Amendments to the Drawings:

Remarks

GARY WAYNE YEWDALL et al.

Figure 1.

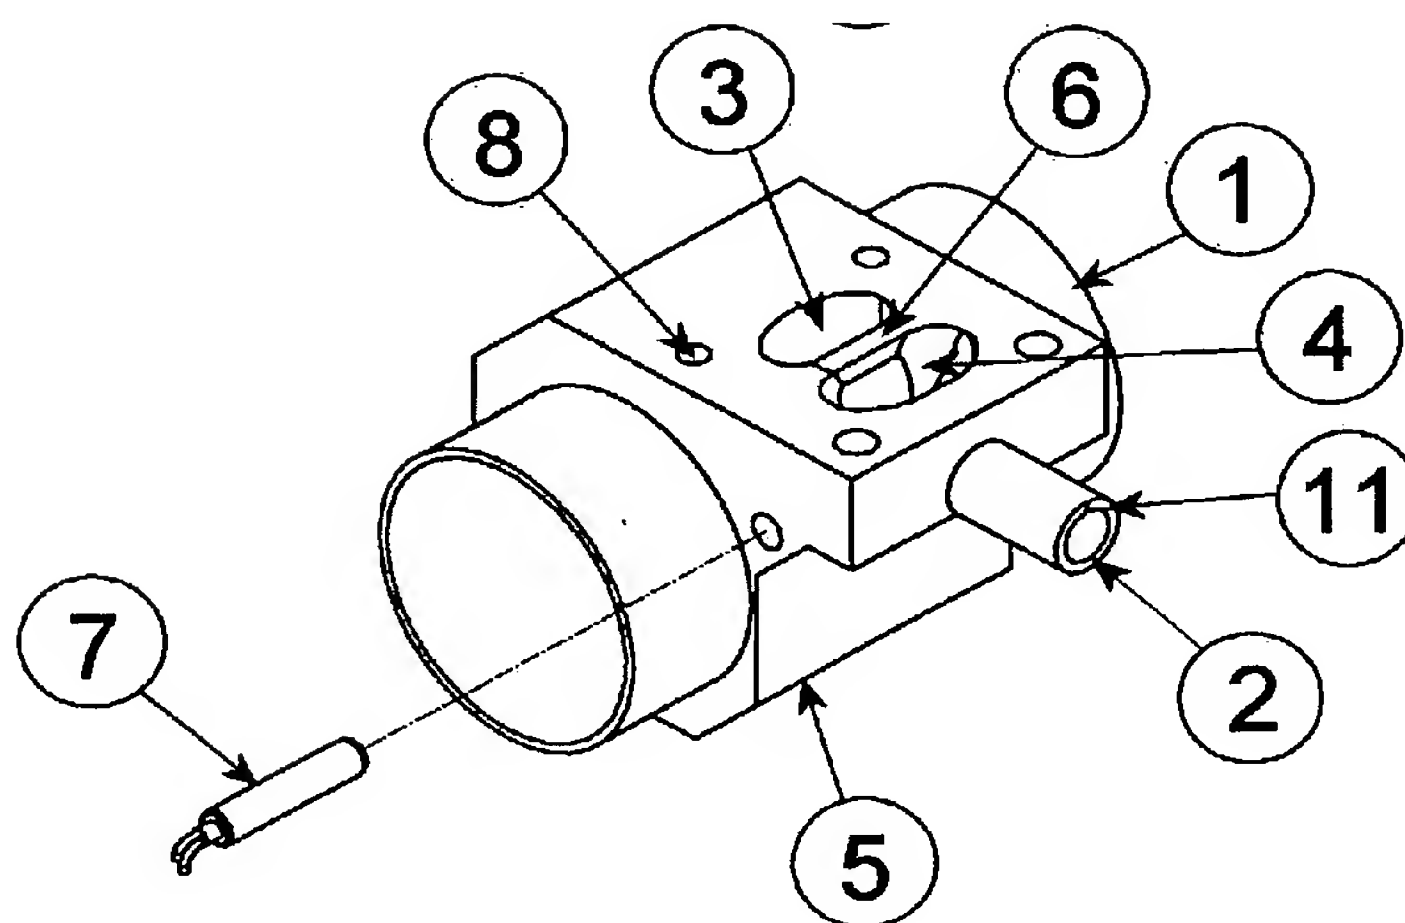
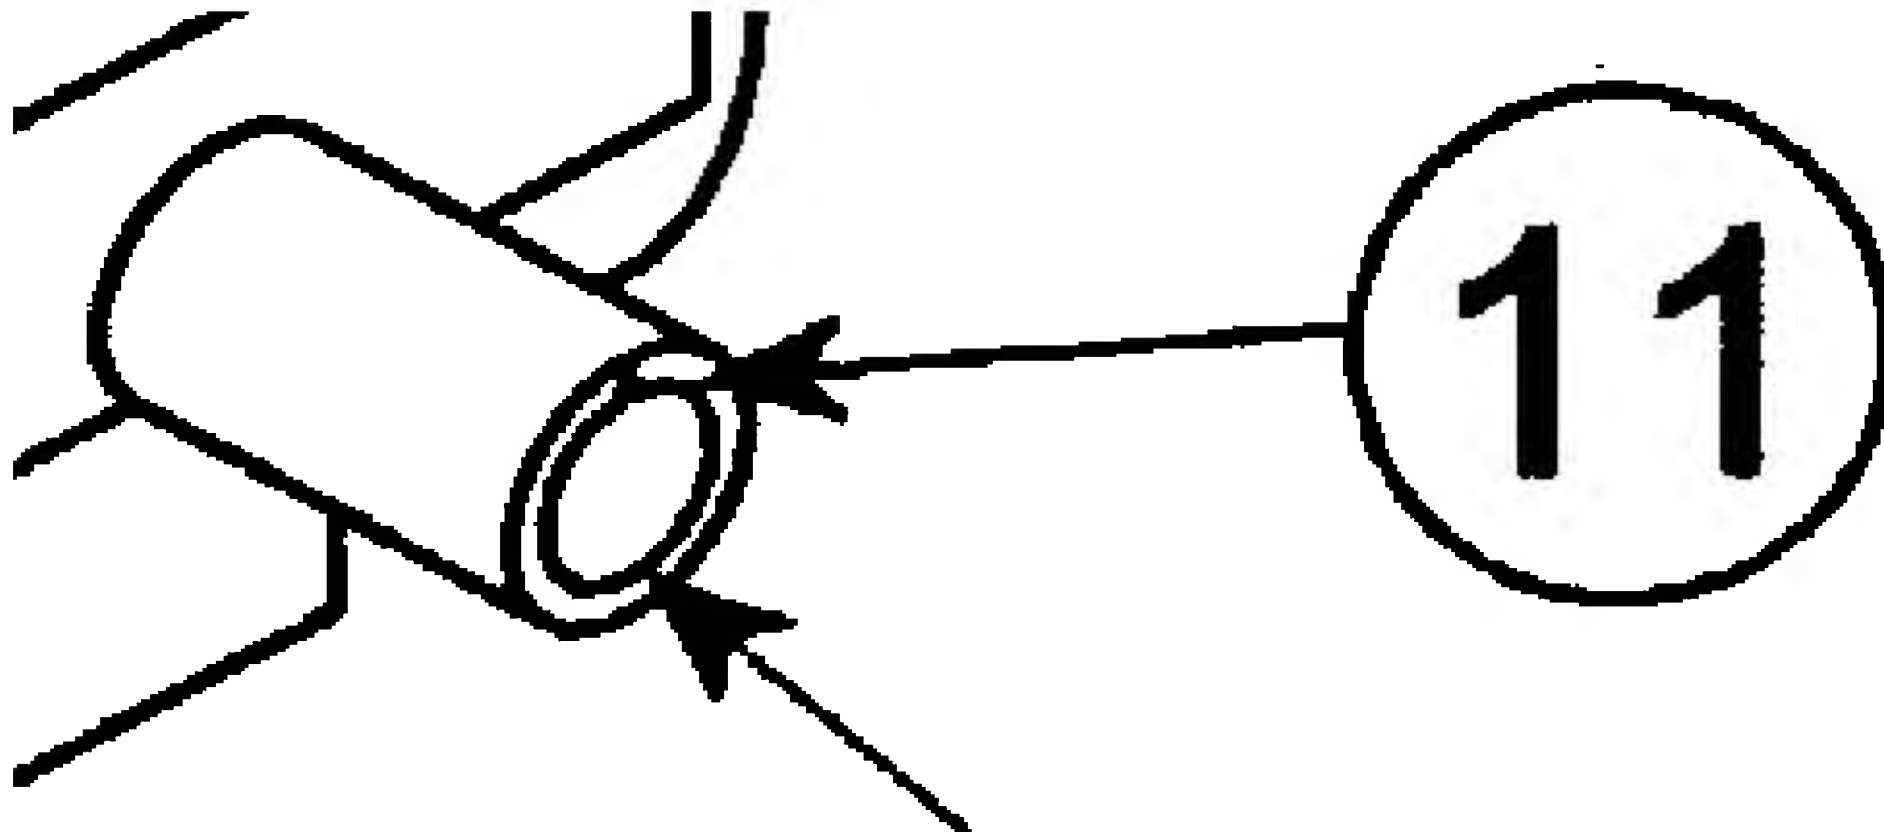
The Examiner has objected to the drawings, stating that "there is no adequate support for such a notch or for an axially extending discontinuity in the original application." (Page 2 of the Office Action of October 14, 2009). And "Figure 1 uses the label 11 and does not show a notch or an axially extending discontinuity." *Id.* Applicant respectfully disagrees. The notch/discontinuity 11 is present in Figure 1. Below is a portion of Figure 1 as originally filed.

A closer examination of Figure 1 illustrates the notch/discontinuity 11 formed on an upper portion of the downstream connector 2, as shown below.

Figure 2.

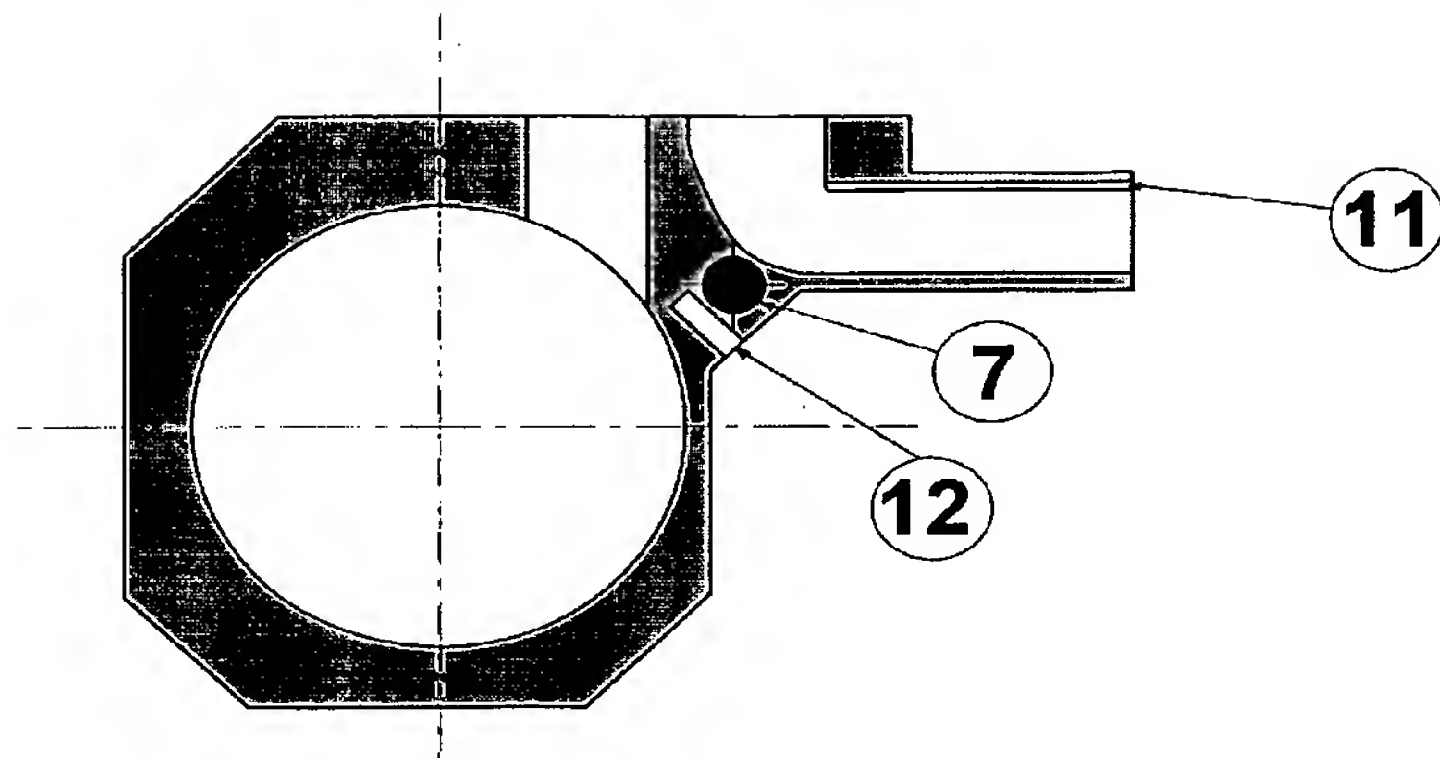
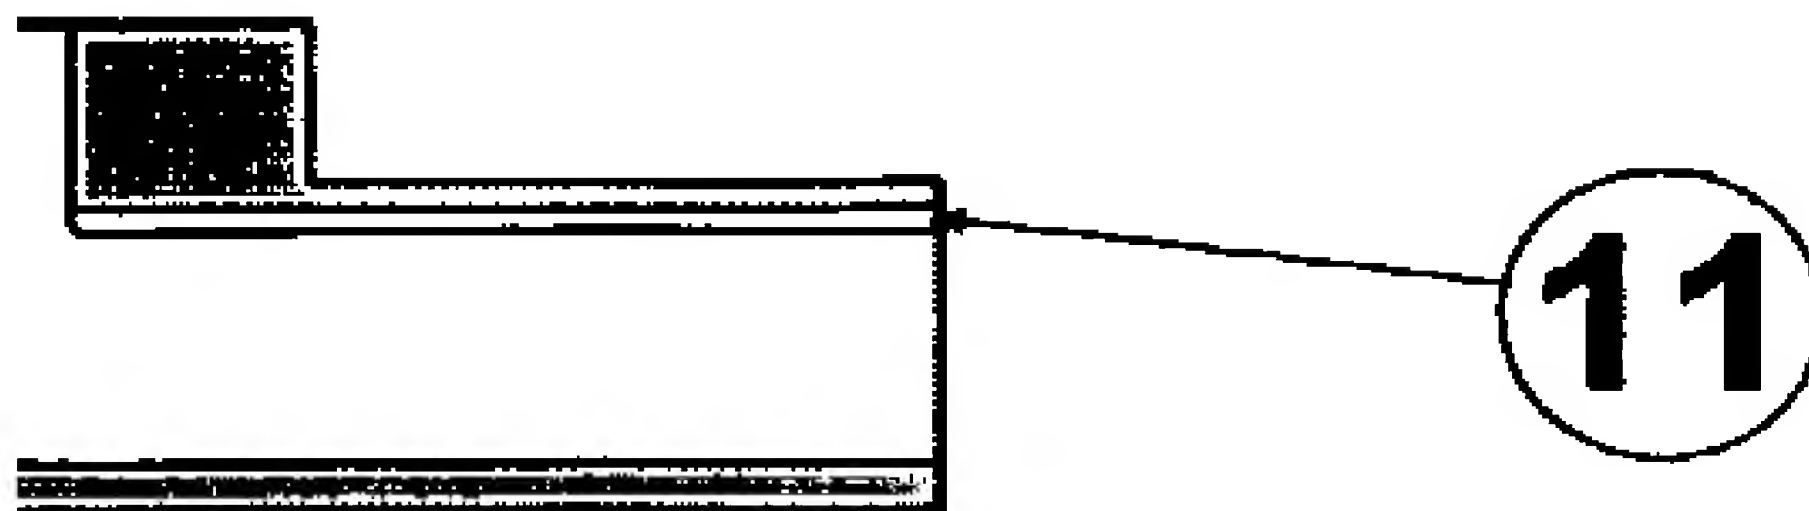
Applicant discloses "[w]ith reference to Figure 2, . . . the down stream connector plain outlet type nozzle (2) can be optionally contoured on the upper portion of said nozzle, as shown (11) to help assist in unlocking any held-up medium in the nozzle when the valve is closed in order to promote rapid free draining of the nozzle." (Specification at page 6, starting at line 5, as amended by this paper). The Examiner states "[i]n particular, Figure 2 is ambiguous since the upper part of nozzle 2 is shown as being the same as the lower part, which does not have a notch". (Page 2 of the Office Action of October 14, 2009). Applicant respectfully disagrees. The upper and lower portions of the downstream connector are not shown as being the same in Figure 2. Figure 2 as filed is illustrated below.

A closer examination of Figure 2, illustrates the notch/discontinuity 11 axially extending along the length of the downstream connector.

FIG. 2

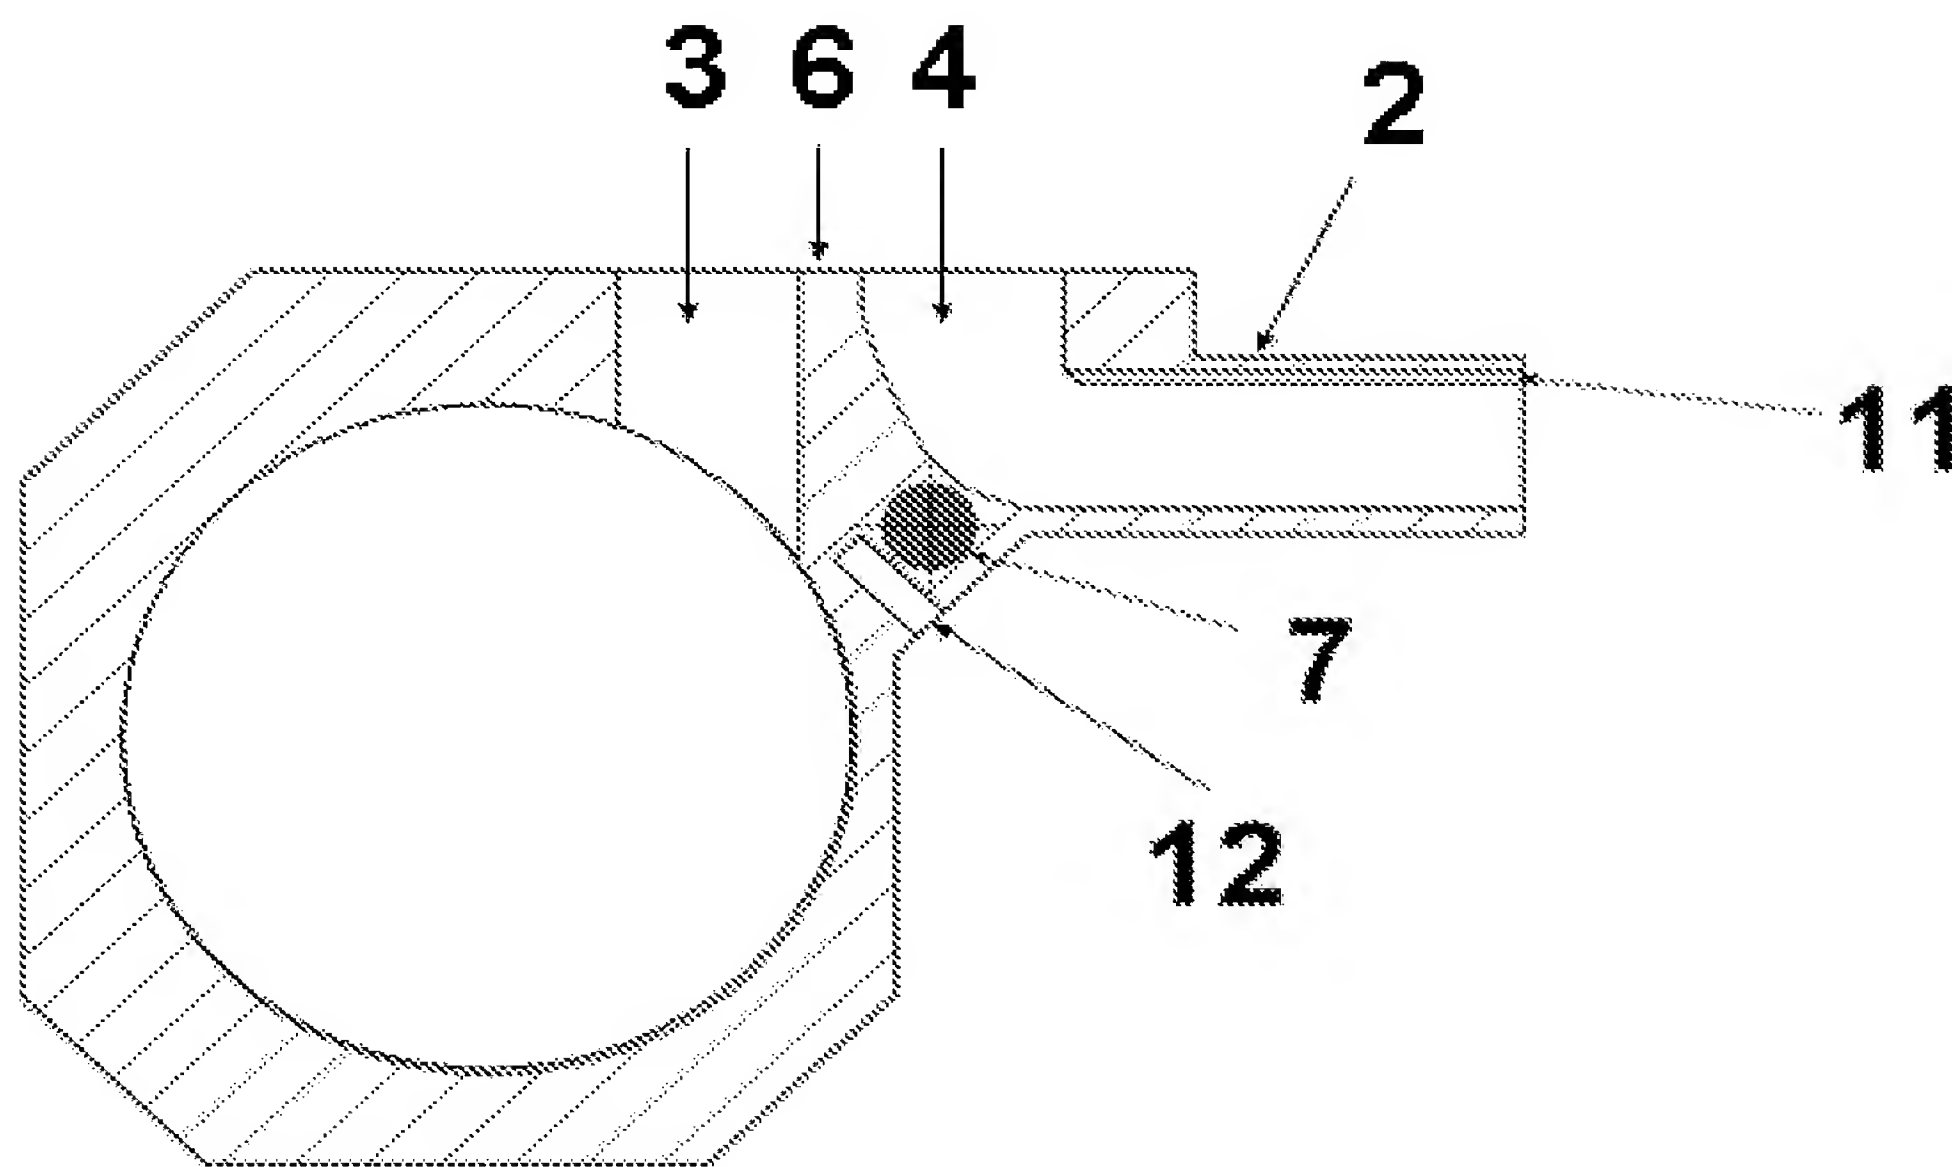
By this paper applicant withdraws Figures 1A, 1B and 2A which were added in the amendment filed on January 16, 2009, to further prosecution. The remaining Figures 1 and 2, previously presented in the amendment of January 16, 2009 are clearer reproductions of Figures 1 and 2 as originally filed and do not present new matter. Replacement Figure 2 is shown below and illustrates the notch/discontinuity formed on the upper portion of the downstream connector 2.
